# **Proposed Marlborough Environment Plan**

Section 42A Hearings Report for Hearing Commencing May 28 2018

# Report on submissions and further submissions Topic 9: Natural Hazards

Report prepared by
Paul Whyte
Consultant Planner (Beca Ltd)

Fig 8: Amended PMEP Level 2 Flood Hazard Overlay - Parkes

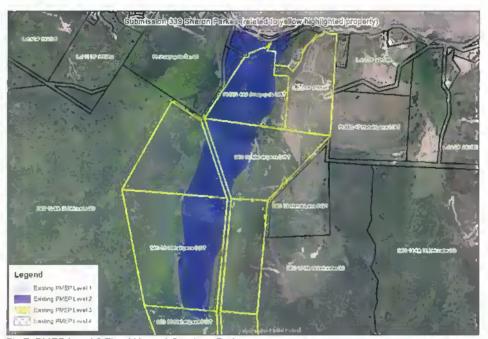
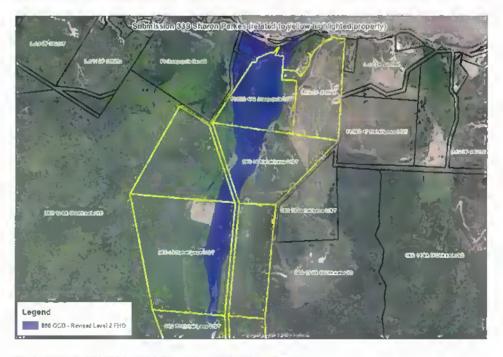
- 83. Accept submission in Part.
- 84. The Level 2 Flood Hazard Area Overlay for the land should be revised. The Level 2 Flood Hazard extent should be reduced to ensure it is more reflective of the local topography as illustrated in Figure 8.
- 85. A detailed hydrologic/hydraulic review would be required to further amend this revised Level 2 Flood Hazard.

Fig 12: Amended PMEP Level 2 Flood Hazard Overlay - Raeburn

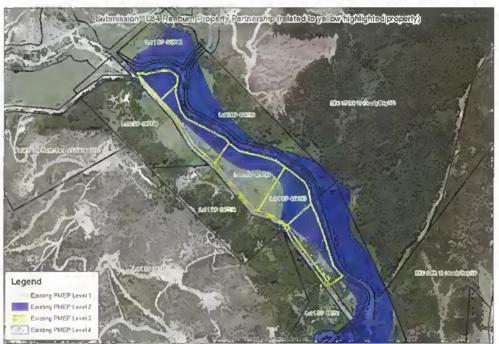
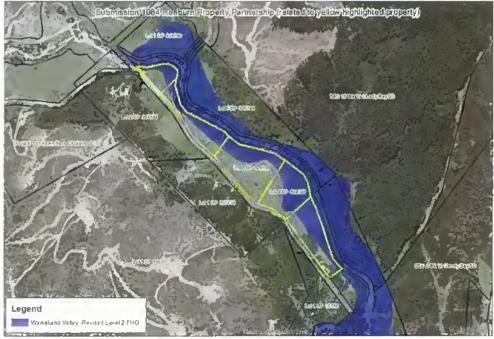
- 110. The site visit provided a better understanding of limited sections of the river terrace topography, which allowed for refinement of the Level 2 Flood Hazard Overlay.
- 111. It is suggested the existing Level 2 Flood Hazard Overlay be amended to follow a more realistic terrace topography, which was confirmed during the site visit (refer Figure 12 overleaf).

- 112. Accept Submission in part.
- 113. The land should remain in Level 2 Flood Hazard with a reduced Level 2 Flood Hazard Overlay extent on the land as shown in **Figure 12**.
- 114. To further revise this amended PMEP Flood Hazard Area Overlay a more extensive site study, detailed topographical survey, and possibly flood hydraulic analysis would be required.

Fig 15: Amended Level 4 Flood Hazard for Tuamarina Pocket (light red cross hatch = existing PMEP Level 4 Flood Hazard Overlay, dark red outlined area = amended Level 4 Flood Hazard Overlay

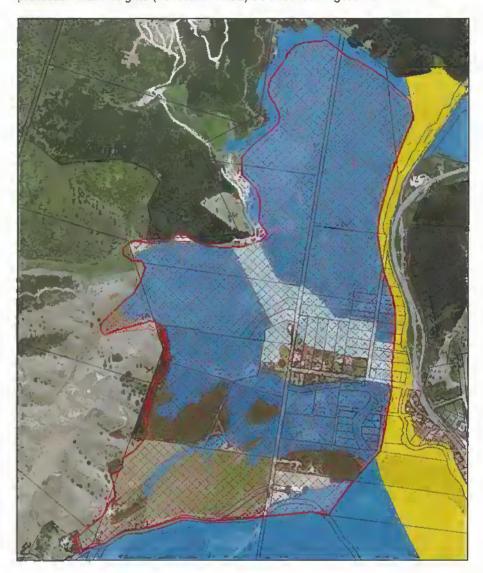
153. The existing Level 4 Flood Hazard Area Overlay in the PMEP applying to the Tuamarina Pocket should remain, but subject to a slight revision on the western extent to match the surrounding river protection work heights (i.e. 9.5m AMSL) as shown in Figure 15.

Fig 28 - Flood Hazard Overlay for Tuamarina Pocket (R Parkes)

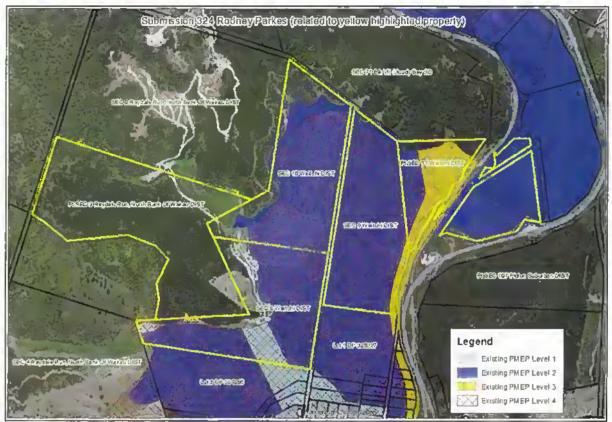
- 173. Rodney Parkes (Windermere Forest Limited)
- 174. Reject Submission
- 175. The land should remain in Level 2 Flood Hazard as shown in Figure 28.
- 176. The land should also remain in Level 3 & 4 Flood Hazard Area Overlay as shown in Figure 28.

Fig 29: PMEP Flood Hazard Overlay - Bown & White

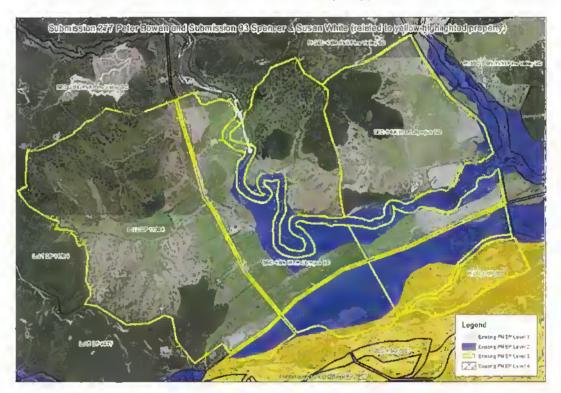
- 192. Reject Submissions from Bown (ref 277.7) and White (93.11 & 93.15)
- 193. The Level 2 & 3 Flood Hazard Area Overlays proposed in the PMEP for the properties related to Submission 277 and 93 should remain as currently mapped in the PMEP (refer **Figure 29**).

Fig 31: Amended PMEP Level 1, 2 & 3 Flood Hazard Overlay - Timms, Wilhelmus & Ormond

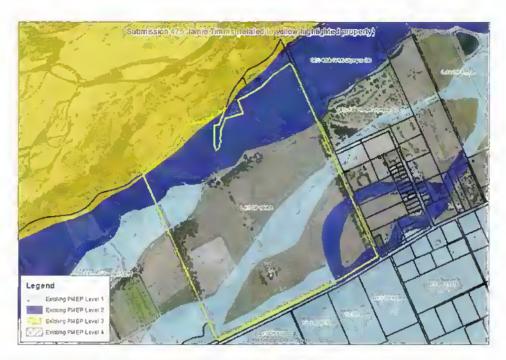
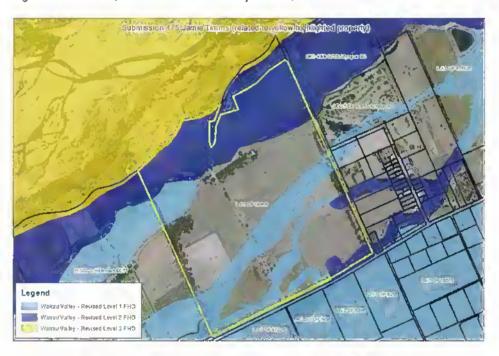
- 209. Accept the Submission in Part,
- 210. The Level 1, Level 2, and Level 3 Flood Hazard Overlays throughout the property should be amended to reflect the actual overland flow paths and terrace formation. These changes are illustrated in Figure 31.

- a reduction from Level 3 to Level 2 Flood Hazard is warranted at the north-west end of the property - refer Figure 31
- a reduction in a section of the Level 2 Flood Hazard to Level 1 at mid property east to Keith Coleman Lane is also warranted - refer Figure 31.

Fig 41: Amended PMEP Floodway Zone - Tschepp & Parkes

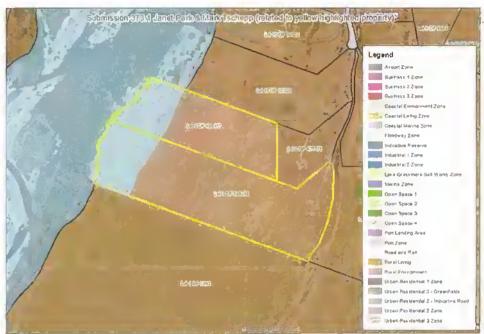
- 280. Accretion land on the western side of the property has had earthworks carried out (i.e. minor private stopbank) which mitigates flooding on the accreted section of the property.
- 281. Since the Level 2 Flood Hazard Overlay still applies and given that some private protection works have been completed (low bund) which partially protects the land it is recommended the Floodway Zone boundary be revised as illustrated in Figure 41.
- 282. Following review of the Floodway Zone requirement we agree with the submitter that the Floodway Zoning can be removed. Zoning should revert to **Rural Environment Zone refer to Figure 41**. The previously identified Floodway Zone should be reclassified as **Rural Environment Zone**.

## 283. Accept the Submission.
